# CHATFIELD STORAGE REALLOCATION PROJECT

### TAC RECOMMENDATION DOCUMENT - No. 03

SUBJECT: Fluctuation Zone Tree Management

## Memorandum

**Figure 1**  
**Distribution of Cottonwoods and Sandbar  
Willows below 5444 Ft Elevation**

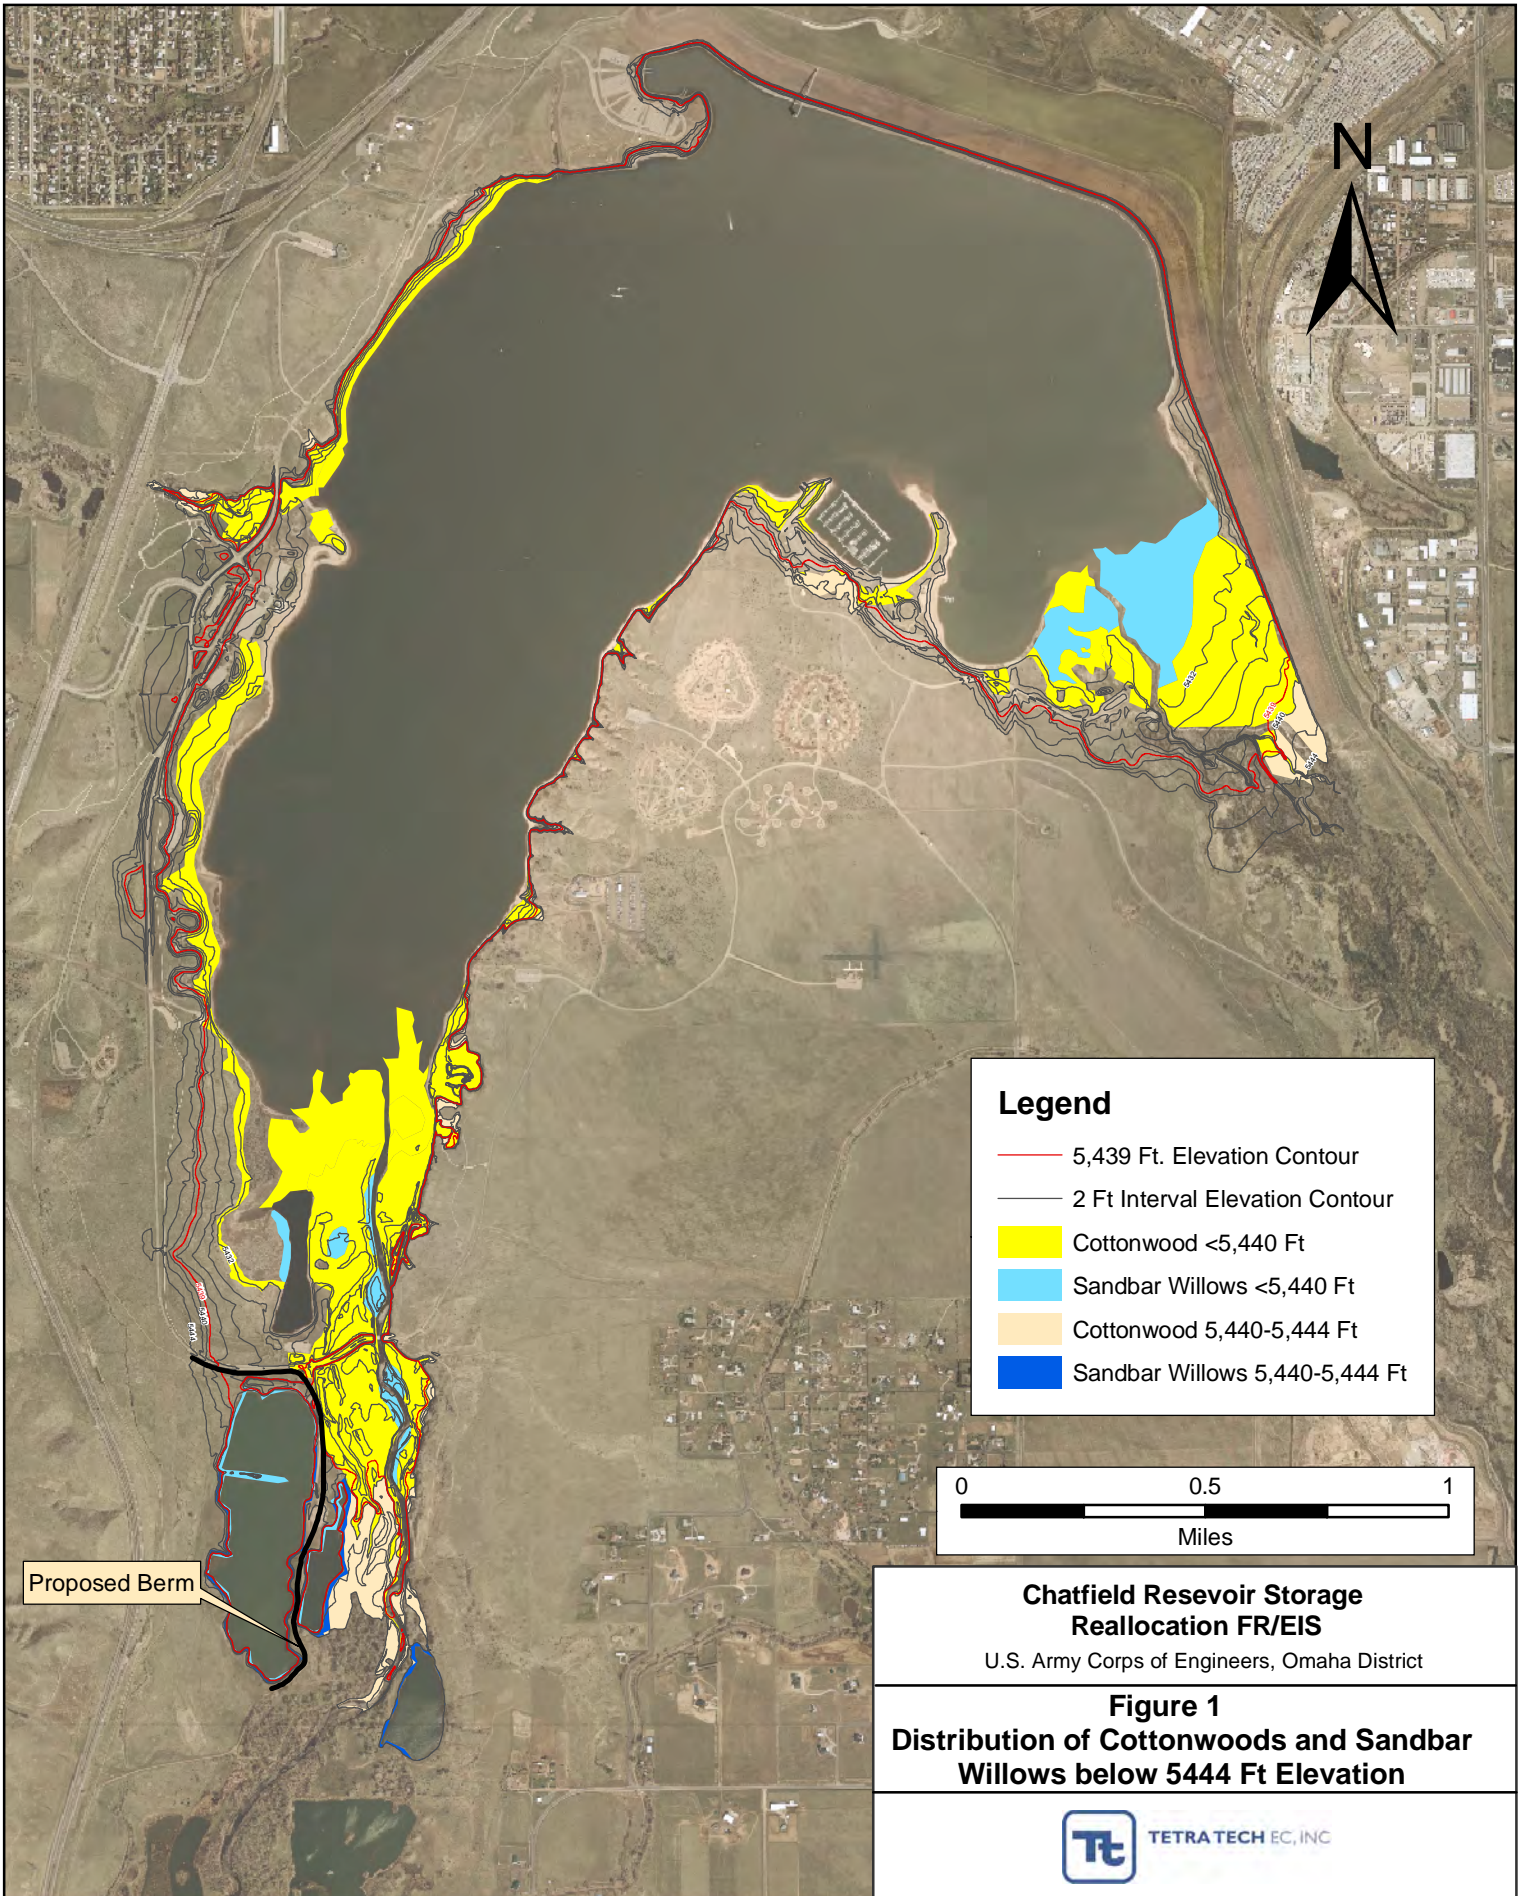
- Cottonwood and willow locations as identified on Figure 1 of Appendix Z should be reviewed and verified or modified as appropriate to identify potentially impacted tree areas below El 5432.0, between El 5432.0 and El 5435.5, between El 5435.5 and El 5437.5, between El 5437.5 and El 5439.0 and between El 5439.0 and El 5444.0. See attached reference document prepared from 2014 LiDAR data. Field verification of these elevation zone assessments should be conducted by the consultants for EM1- EFU Independent Technical Review, EM2 – Preliminary Design of On-site Environmental Mitigation, RM1 – Preliminary Design of the Marina and RM2 – Preliminary Design of Recreation Facilities Modifications.

The TAC recommends to use the Adaptive Management approach to managing trees within the Fluctuation Zone as described above, with the exceptions that: 1) the suggested debris screen not be implemented and 2); the CPW be included, along with the PCT and the TAC as reviewers of the refined Tree Management Plan.
